SSDs 6964, 6965 and 6966 - Barangaroo South Residential Towers R4A, R4B and R5

**Response to Submissions for State Significant Development Applications SSD
6964 and 6965 for Barangaroo Residential Buildings R4A and R4B,
Barangaroo South**

Figure 1: Extract from Wind Assessment showing trees required to mitigate wind impacts.

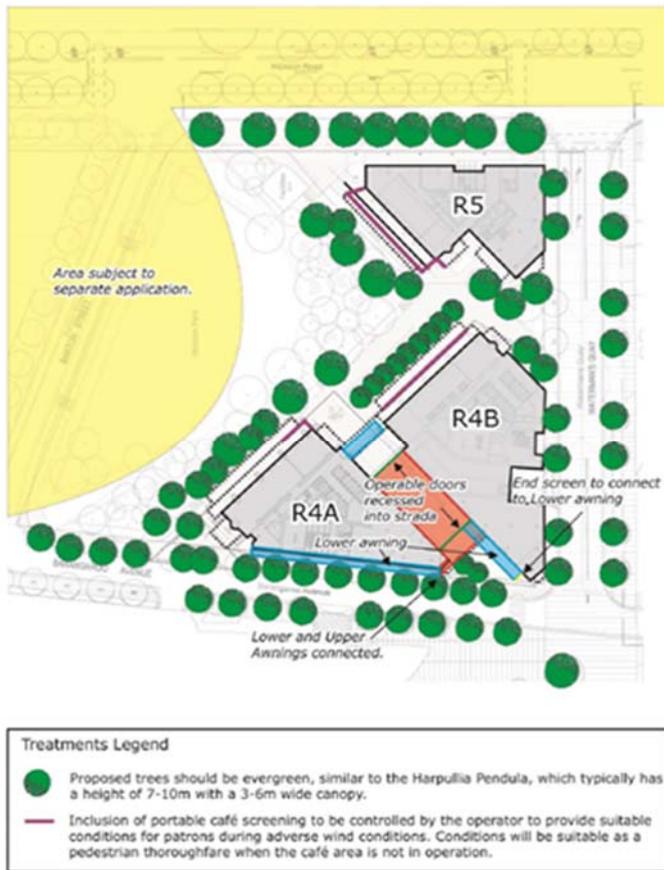
There is a significant issue with the pedestrian wind environment created by these towers. The wind report, prepared by Windtech illustrates dense lines of trees that are positioned around the edges of each building. These trees are required to achieve a height of 7-10m, with a dense canopy of 3-6m wide (refer Figure 1 below).

1. the landscape design report states that 'for technical reasons large tree planting is not possible above the floors below on podium level' (sic). The phrase is obviously a typing error, however the true meaning is quite critical. If the 'technical reasons' prohibiting large tree planting apply to all large trees on podium, presumably this excludes large trees above the basement.
2. the location of the deep soil pockets is unknown, so there is a further lack of guarantee that the required trees would be planted in the required location. The SSD applications are lodged on the basis that the buildings and immediate surrounds sit on a basement that is shallow of the ground level.

It is highly likely that the proposed tree locations shown in the wind report will not align with a well-considered park design. The trees are not placed with consideration to design constraints or opportunities, and the proposed species matches the street trees, thereby lacking diversity.
